DESCRIPTIVE REPORT

H11344

General Locality: **Tampa Bay**

HYDROGRAPHIC SURVEY H-11344

Figure 1.1.1

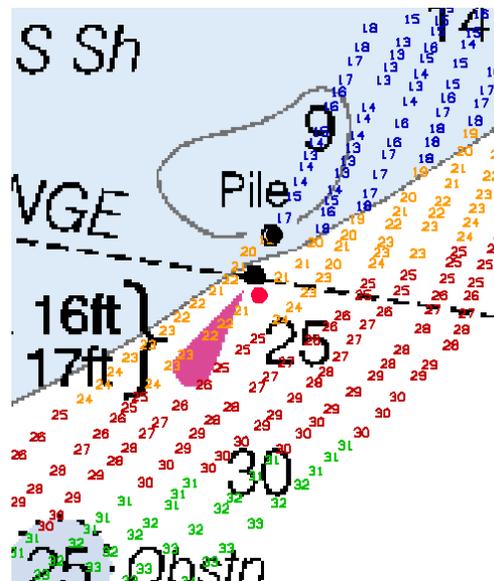
Survey Position: 027° 47' 33.852" N, 82° 35' 13.460" W
Least Depth: -1.98 m
Timestamp: 2004-160.14:43:16.000 (06/08/2004)
DP Dataset: H-11344_A / S_1210_dp_Non_Fatho.hvf / 2004-160 / DPs_H-11344_A
Profile/Beam: 3/1
Charts Affected: 11416_1, 11412_1, 1114A_1, 11400_1, 11451_17, 11006_1, 11013_1, 411_1
Remarks:
 Located new pile.

Chart a pile at $27^{\circ}47'33.852''$, $-082^{\circ}35'13.460''$. *Concur, chart a visible pile.*
